March 13, 2020
NRC-20-0019

Fermi 2 Power Plant
NRC Docket No. 50-341
NRC License No. NPF-43

Subject: Change in DTE Commitment Regarding Containment Coatings
and Additional Information

Figure 1: Pressure Suppression Chamber (Torus) Layout

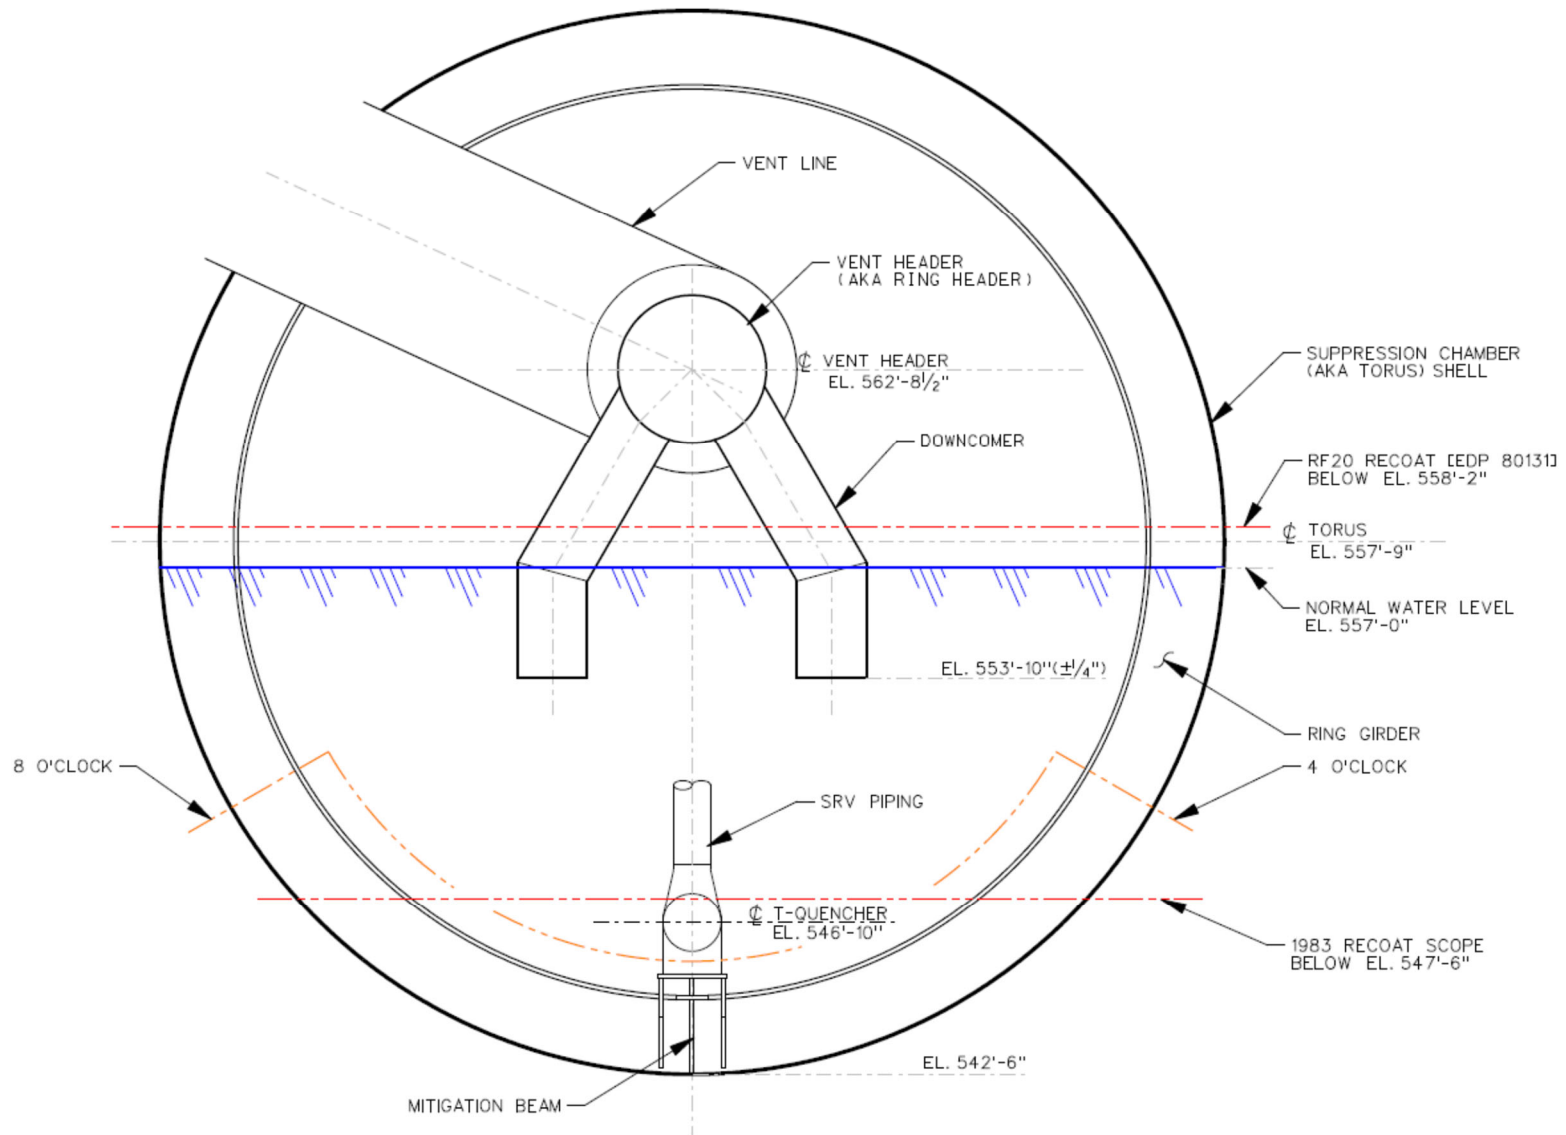
As shown in Figure 1 in this Enclosure, the bottom of the inside of the torus is at an elevation of 542'6". The normal water level inside the torus corresponds to an elevation of 557'. Per the Fermi 2 Technical Specifications (TS), the torus water level is required to be within ± 2 " of this level during Modes 1, 2, and 3. The DTE commitment letter and the NRC CAL both refer to the "submerged portion of the torus." Conservatively using the maximum torus level allowed by the TS, the submerged portion of the torus therefore corresponds to internal areas of the torus below an elevation of 557'2".

- 7,000 square feet of pressure boundary.
- An arc beginning at the torus bottom and extending 12 feet up in each direction, which corresponds to an elevation of approximately 547'3".
- The 4 o'clock to 8 o'clock position, which corresponds to an elevation of approximately 550'3".

Using the most conservative of these methods (based on surface area), the extent of the degraded coating region is the internal areas of the torus up to an elevation of 550'3". This extent of condition is well below the maximum torus water level of 557'2". Therefore, removing all coating below elevation 557'2" and applying a qualified coating capable of withstanding design basis accident conditions will fulfill the intent of the commitment to "mitigate the degraded coating in the submerged portion of the torus" with margin.

Consistent with this understanding, the DTE torus coating project plans to remove the current coating from the external surfaces of the bottom of the downcomers and apply the same DBA-qualified coating as will be used on the torus. Given the planned removal elevation of 558'2" as shown in Figure 1 of Enclosure 1, this will result in new DBA-qualified downcomer external coating with a foot of elevation margin above the normal submergence of the downcomers.

The DTE torus coating project plan is to remove and replace coatings below an elevation of 558'2", excluding downcomer and process piping internal surfaces as clarified in the commitment change and also in the above discussions. This project scope elevation is one foot above the 557'2" elevation of the submerged portion of the torus. Although beyond the requirement of the DTE commitment and NRC CAL, recoating to this higher elevation ensures that the interface between the new and existing coatings is well above the normal torus water line.
